ADDENDUM #1
March 11, 2022

PROJECT: **Beck Road Lift Station and Force Main Improvements**

OWNER: City of Commerce

2. CONSTRUCTION PLANS, SHEETS C0.0, C1.0, C3.0, E1.1, & E2.1

SHEET NO:
C1.0

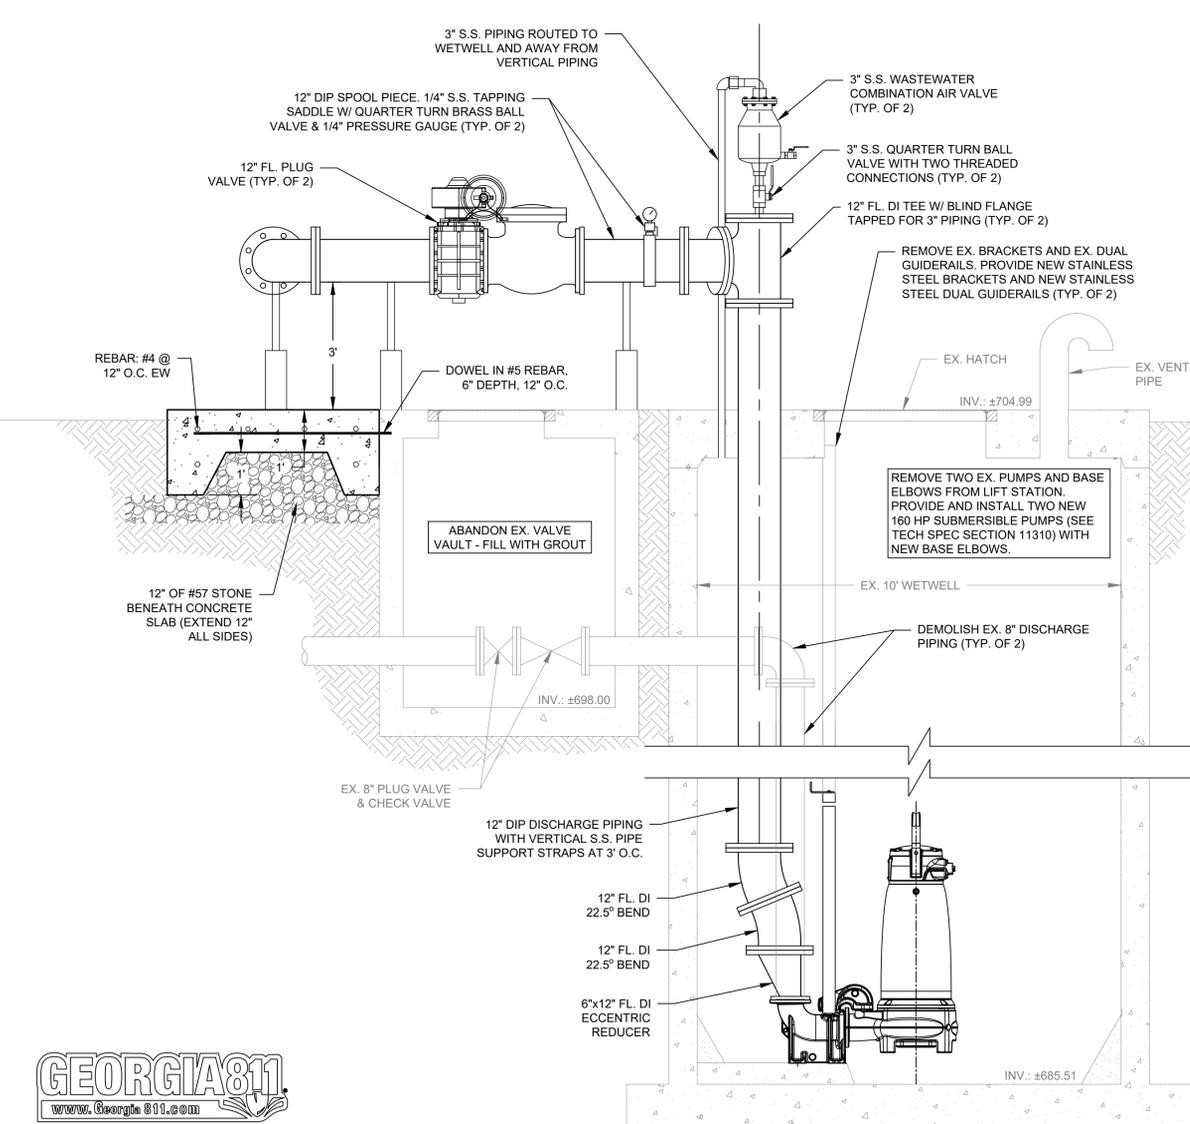
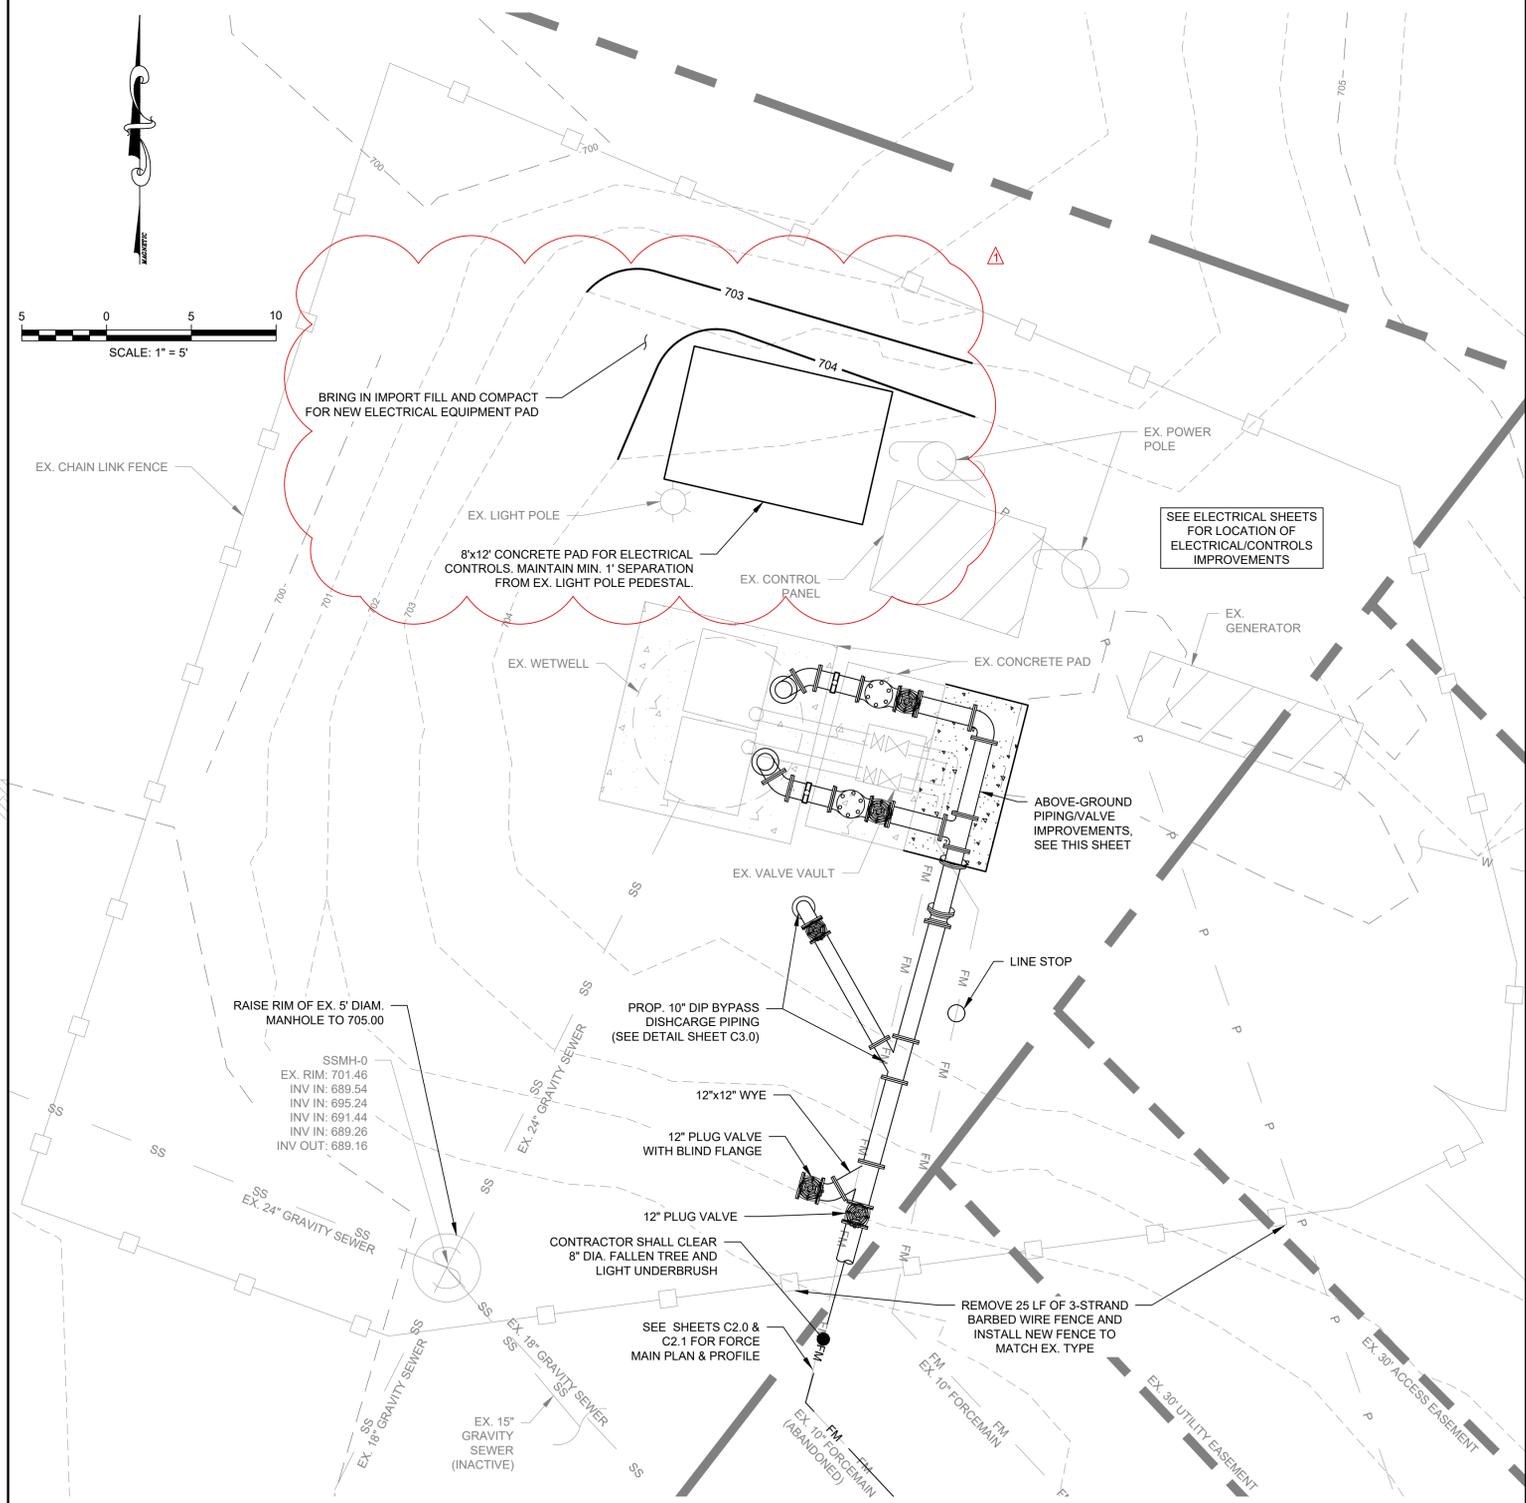
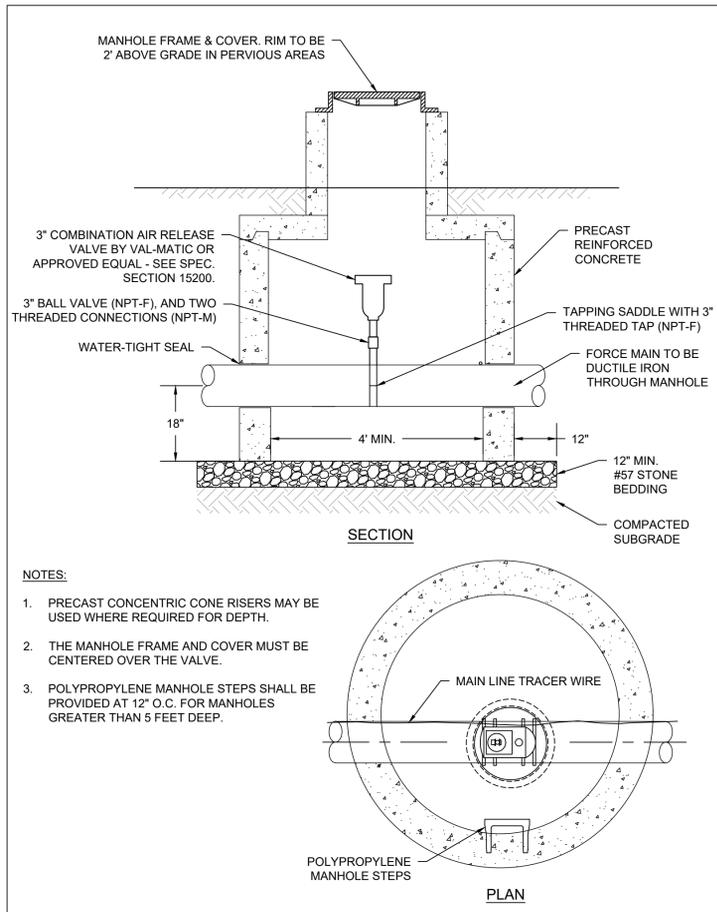
- a. Minor site grading at the lift station will be required for installation of the concrete slab for electrical controls and shall be included under the line item in the Bid Form for Lift Station Improvements Complete.

- ALL DUCTILE IRON PIPE, VALVES, & FITTINGS SHALL BE LINED WITH 401 PROTECTO LINING OR TNEMEC 431 LINING.
- PROVIDE "STANDON S89" PIPE SUPPORTS AS NECESSARY TO SUPPORT ABOVE-GROUND PIPING, FITTINGS, AND VALVES. SEE DETAIL SHEET.
- REQUIREMENTS FOR EXTERIOR PAINTING OF ABOVE-GROUND DUCTILE IRON STEEL PIPES, FITTINGS, AND VALVES:
 PROP. SYSTEM TYPE: EPOXY/EPOXY/URETHANE.
 PROP. SURFACE PREPARATION: SSPC-SP 6.
 PROP. PRIMER: SERIES N69-1255 BEIGE POXIPRIME II. DFT 3.0 TO 5.0 MILS.
 PROP. INTERMEDIATE COAT: SERIES 66 HI-BUILD EPOXOLINE. DFT 2.0 TO 3.0 MILS.
 PROP. FINISH COAT: SERIES 1075 ENDURA-SHIELD II. DFT 2.0 TO 5.0 MILS.
 PROP. TOTAL DFT: 7.0 TO 13.0 MILS.
 PROP. FINISH COLOR: [AS SELECTED BY ENGINEER] FROM MANUFACTURER'S STANDARD COLORS.
